STAFF RECOMMENDATION
3649 Richland Avenue
Lot 3, Richland Hall Development
May 18, 2016

Application: New construction—infill and outbuilding; Setback determination
District: Richland-West End Neighborhood Conservation Zoning Overlay
Council District: 24
Map and Parcel Number: 10409028200
Applicant: Chad Gore, Mike Ford Builders
Project Lead: Melissa Baldock, melissa.baldock@nashville.gov

Description of Project: Application is to construct a new single family infill and an outbuilding. Both the infill and the outbuilding are to be located three feet (3') from the interior property line. Since base zoning requires a five foot (5') side setback for both structures, the project requires a setback determination

SITE PLAN

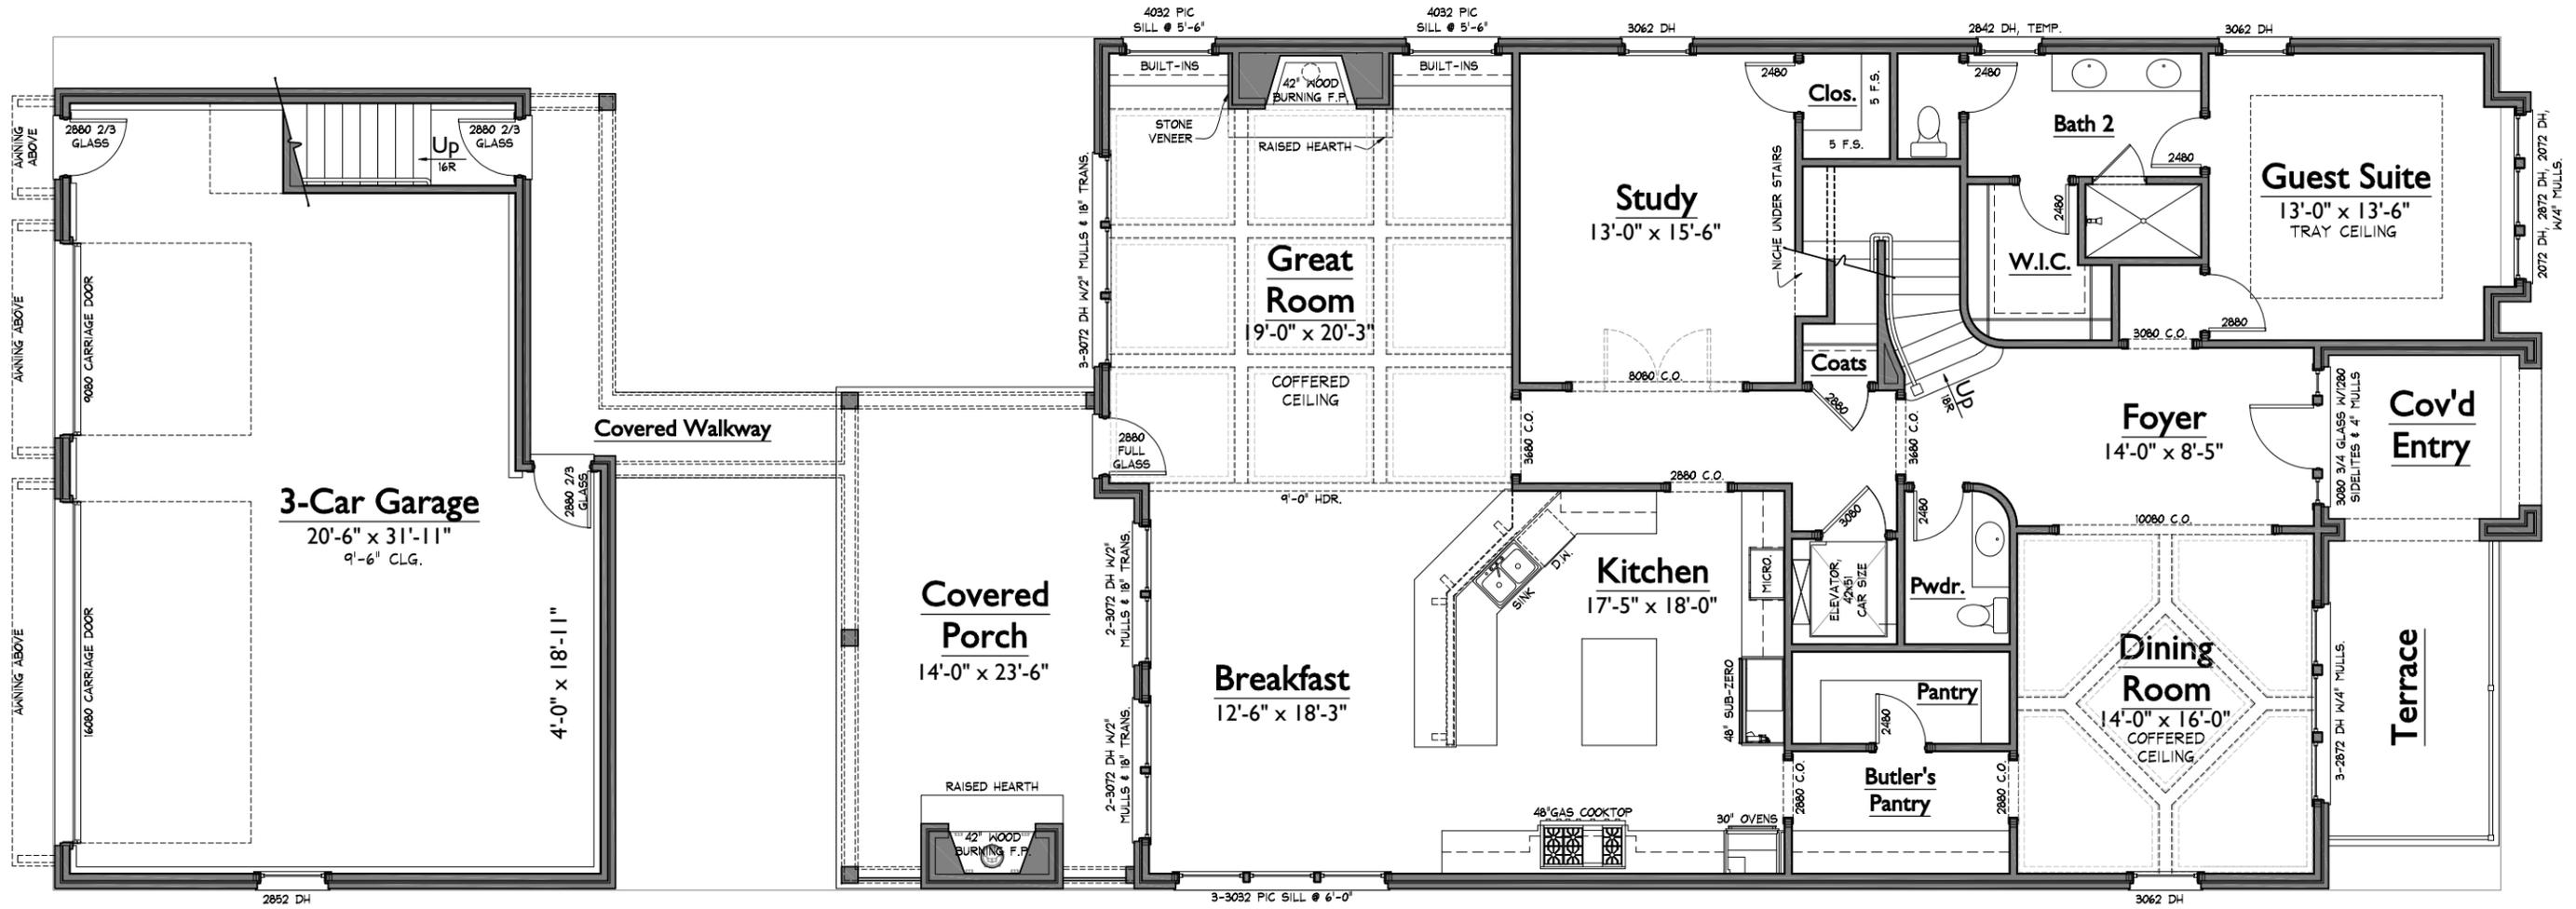
Setback & Rhythm of Spacing: In May, the Commission approved a plan that showed that the front-yard setbacks for new construction on the south side of Richland Avenue will be approximately forty-feet (40'), matching the context of the one historic building on that block, Davidson Hall. The site plan for 3649 Richland Avenue shows a front setback of forty feet, five inches (40'5"), although the ten-foot (10') wide bay on the right side of the front façade will protrude approximately eighteen inches (18") into this front setback. Staff finds that the front setback encroachment of this modestly-sized architectural features is appropriate and will provide for some relief from the common setbacks proposed for this block of almost all new construction.

The right side elevation will be seven feet (7') from the side property line, which meets the base zoning setback of five feet (5'). On the left side, base zoning requires a five foot (5') side setback, but the applicant is proposing to set the infill just three feet (3') from the side property line. Staff finds this reduced side setback to be appropriate because there are other homes in the immediate vicinity that do not meet the required five foot (5') side setback. In addition, the infill is part of a larger development, and the reduced setback will affect the parcel next door at 3645 Richland Avenue, which is also part of the larger development. Staff has yet to review the site plan for 3645 Richland Avenue, but has directed the applicant that the right side of 3645 needs to be set more than seven feet (7') from the side property line. This will ensure there is at least ten feet (10') in between nos. 3649 and 3645 Richland Avenue and that the reduced side setback will not affect overall rhythm of spacing on the street.

ELEVATIONS

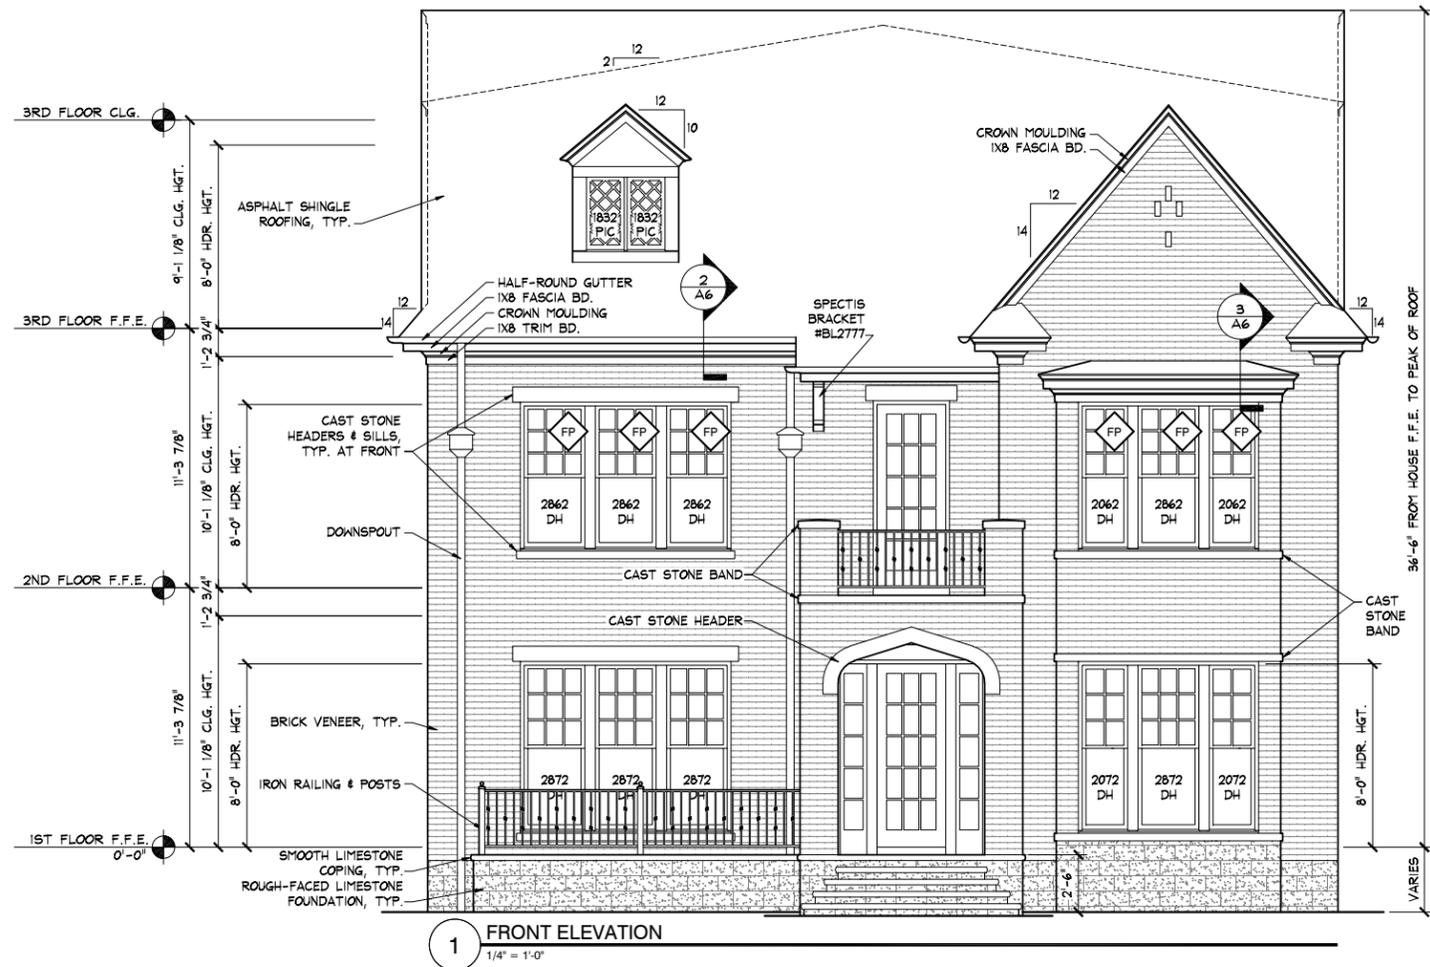
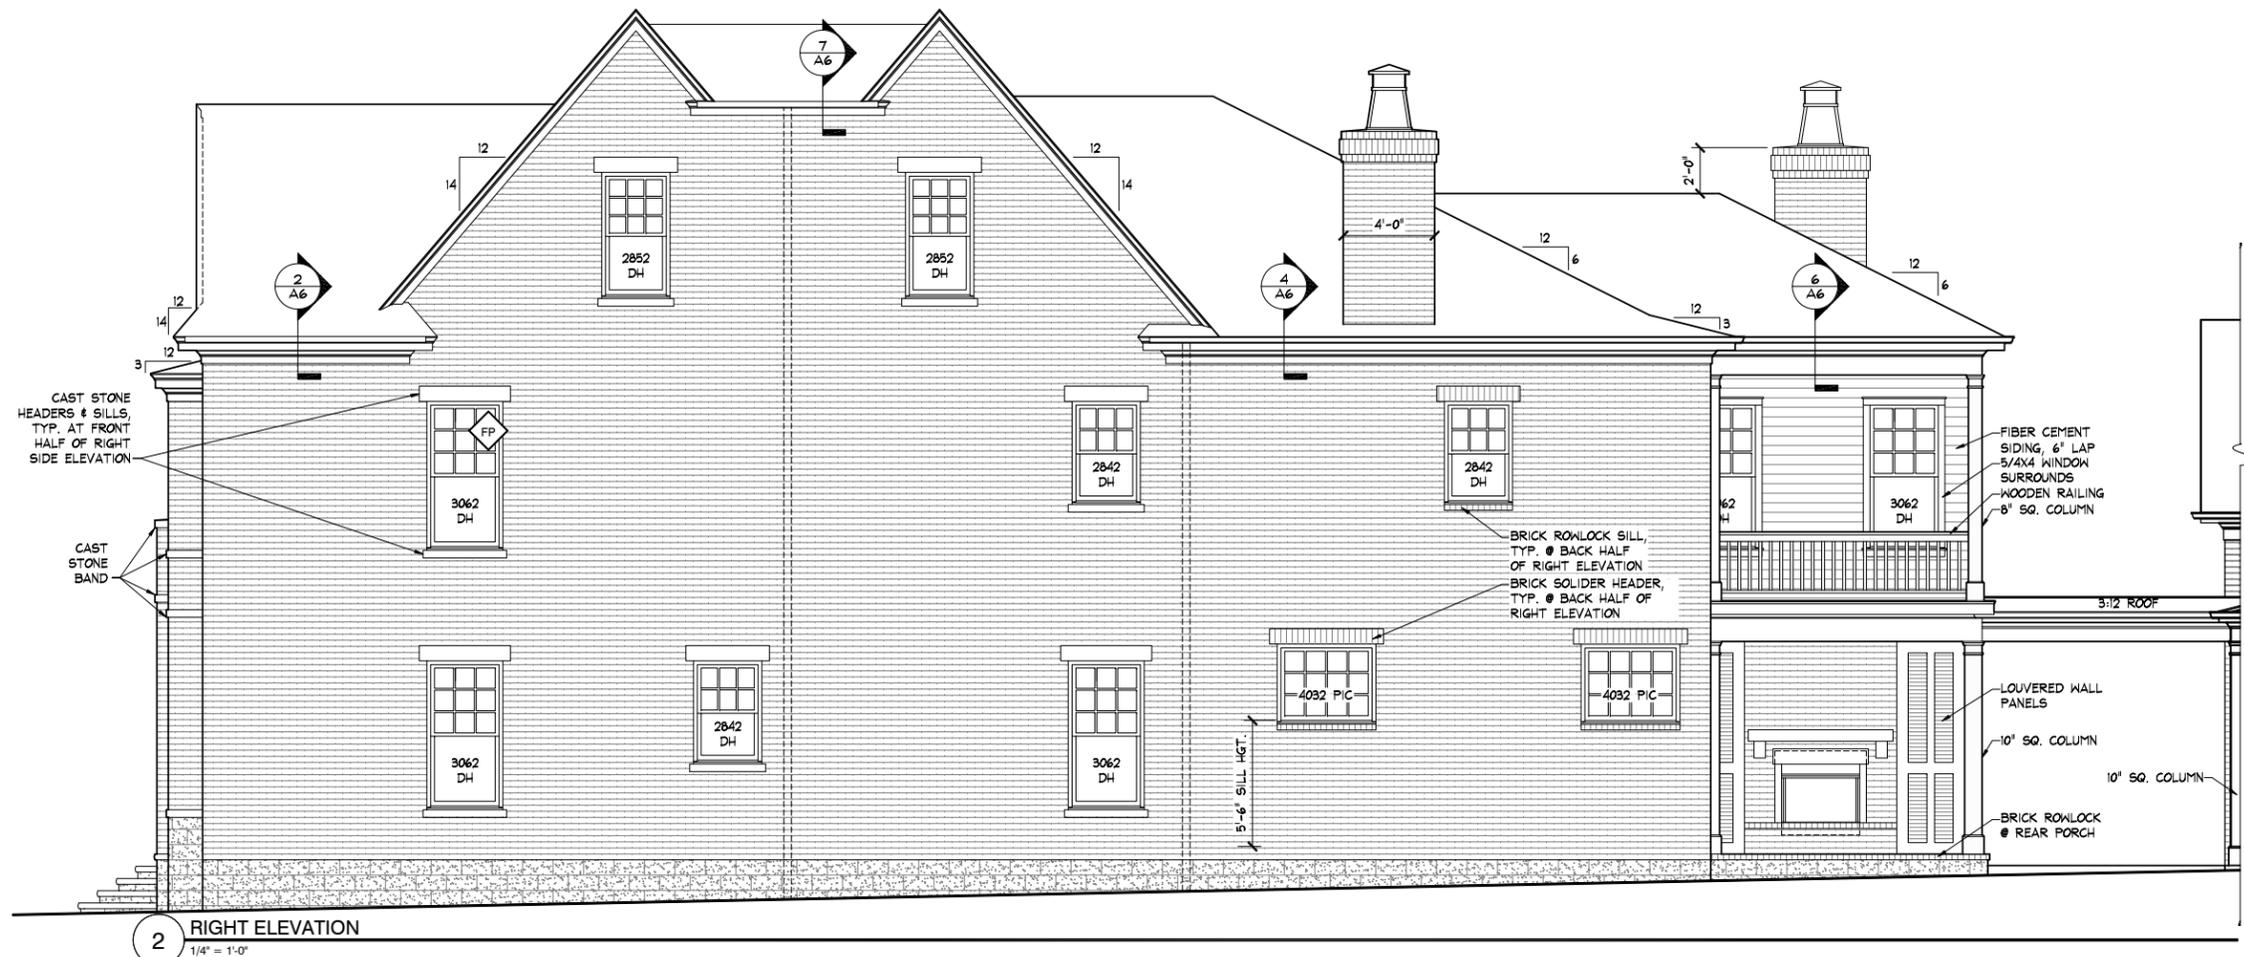
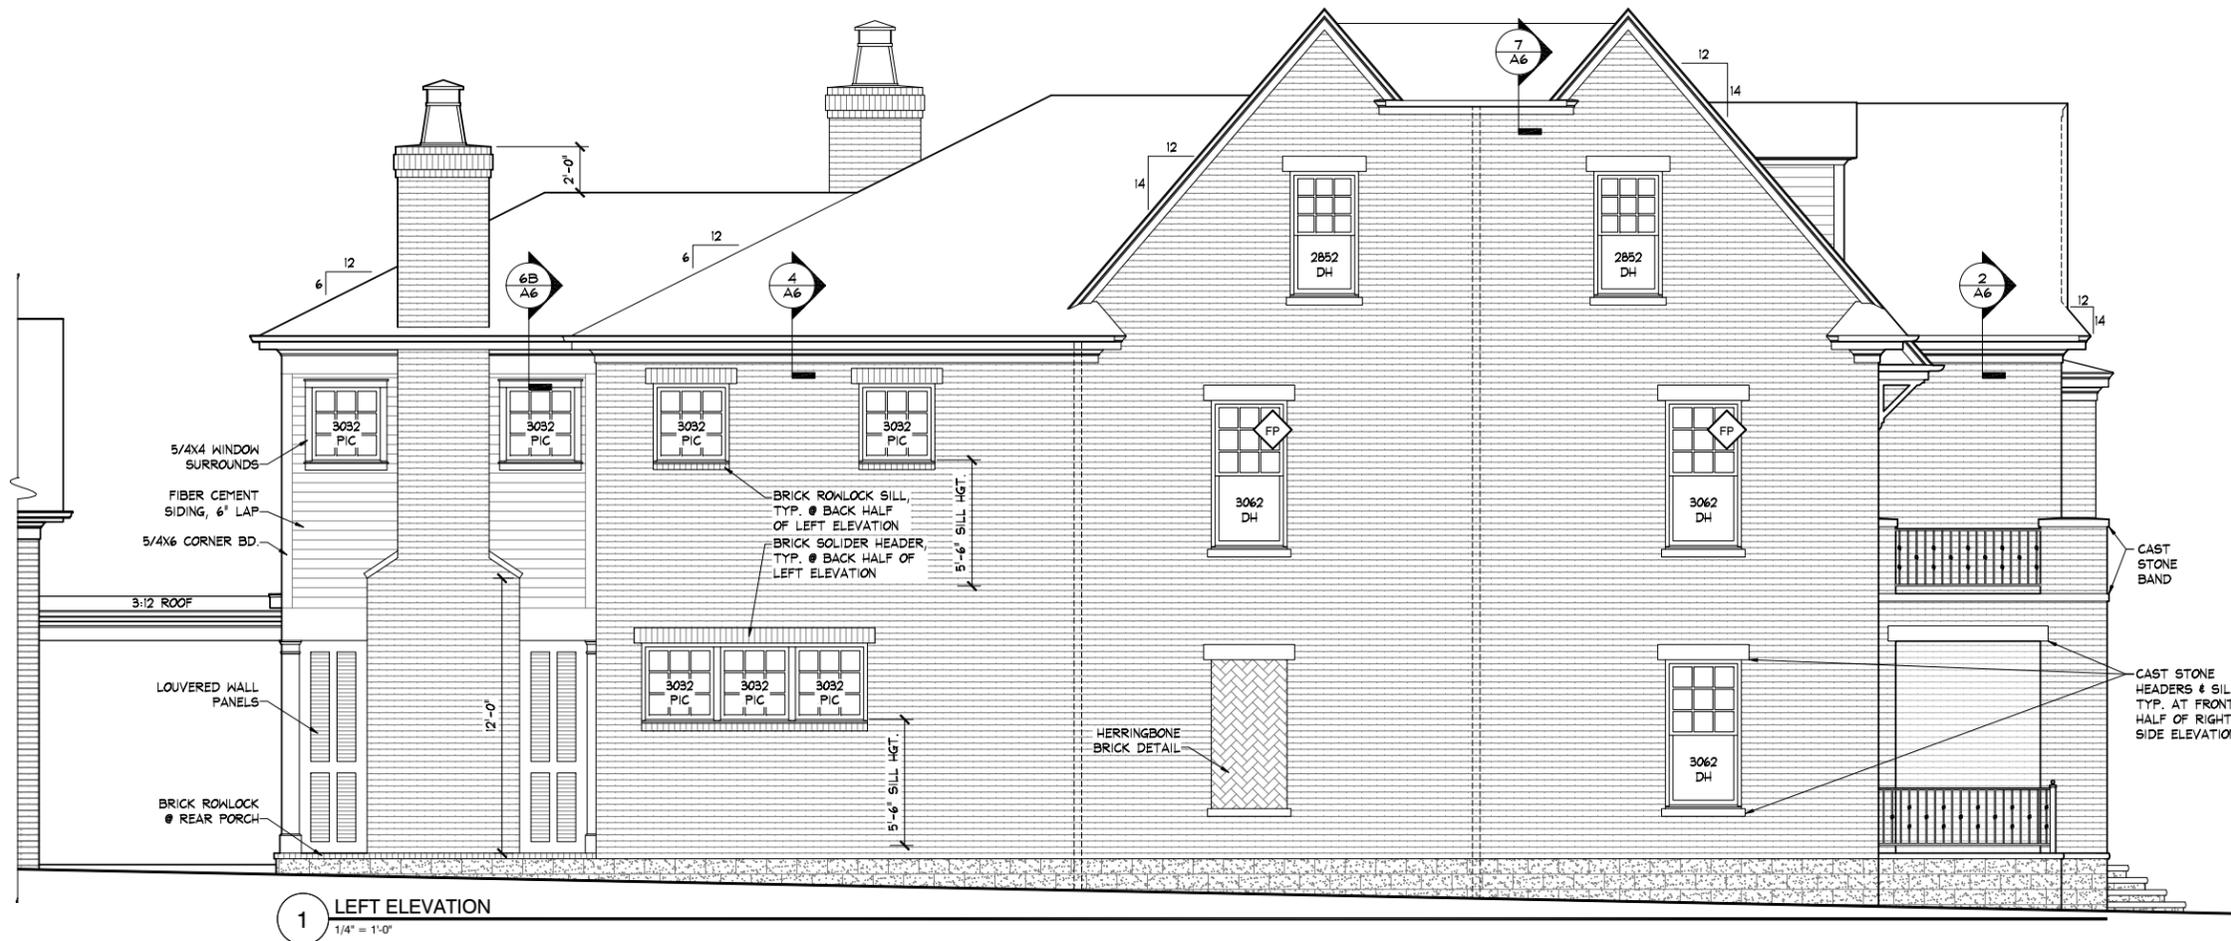
Height & Scale: The proposed infill will be two stories with an eave height of approximately twenty-five feet (25') from grade and a maximum ridge height of approximately thirty-nine feet, six inches (39'6") grade. Staff finds that this meets the overall historic context, as there are both one and a half and two-story houses in the immediate vicinity, and the proposed houses have heights ranging from thirty to forty-four feet (30' – 44'). The foundation height is drawn as approximately two feet (2') tall, at the front. Staff recommends inspection of the foundation height and finished floor system height to ensure that these heights are compatible with the historic context.

Materials: The primary cladding material will be brick, and the foundation will be rough-faced limestone. Staff recommends approval of brick and stone samples prior to purchase and installation. The front gable and a second story extension at the rear will be clad in cement fiberboard; staff recommends that the fiberboard be smooth with a maximum reveal of five inches (5"). The trim will be cement fiberboard and wood. The window lintels and sills will be cast stone. The main roof will be asphalt shingle, and staff recommends approval of the shingle color and texture. The windows and doors are to be wood, and staff recommends approval of all window and door specifications prior to purchase and installation. With the staff's final approval of the material choices, staff finds that the known materials meet Section II.B.1.d. of the design guidelines.

Roof form: The roof's primary form is a broken side gable with a projecting front gabled bay. Both of the gables have slopes of 14/12. At the rear, the roof form switches to a hipped roof with a 6/12 pitch. The front covered entry stoop will have a roof that is flat so that there can be an uncovered balcony on the second story. Uncovered balconies over front porches are seen within the Richland-West End neighborhood, and staff finds the proposed porch roof balcony to be appropriate. Staff finds that the proposed roof forms are appropriate for a two-story infill house in the overlay, and finds that the roof forms meet Section II.B.1.e. of the design guidelines.

Orientation: The infill is oriented towards Richland Avenue, which is appropriate. The entrance to the structure will be located behind a covered entry stoop with a flat roof. The front stoop is ten feet (10') deep. There will be a walkway leading from the sidewalk on Richland Avenue to the front porch steps. Vehicular access to the site will be via a new private alley created at the rear. The alley will be accessed via Craighead Avenue, at the back of the lot at 3657 Richland Avenue. Staff finds that the infill's orientation meets Section II.B.1.f. of the design guidelines.

Proportion and Rhythm of Openings: The primary windows on the infill are twice as tall as they are wide, thereby meeting the historic proportions of openings. The windows on the ground floor are generally taller than the windows on the upper levels. There are no large expanses of wall space without a window or door opening with the exception of the left side, ground floor. A rectangle, the size of other openings with herringbone brick is proposed to break up this façade. Staff finds this to be appropriate since it is far back on the house and will be minimally visible. Staff finds that the infill's proportion and rhythm of openings meet Section II.B.1.g. of the design guidelines.

1. The finished floor height be consistent with the finished floor heights of neighboring historic houses, to be verified by MHZC staff in the field;
2. Staff approve the brick and stone samples prior to purchase and installation;
3. All lap siding be smooth face, with a maximum reveal of five inches;
4. Staff approve the asphalt shingle color and texture; and
5. Staff approve all window and door selections prior to purchase and installation.
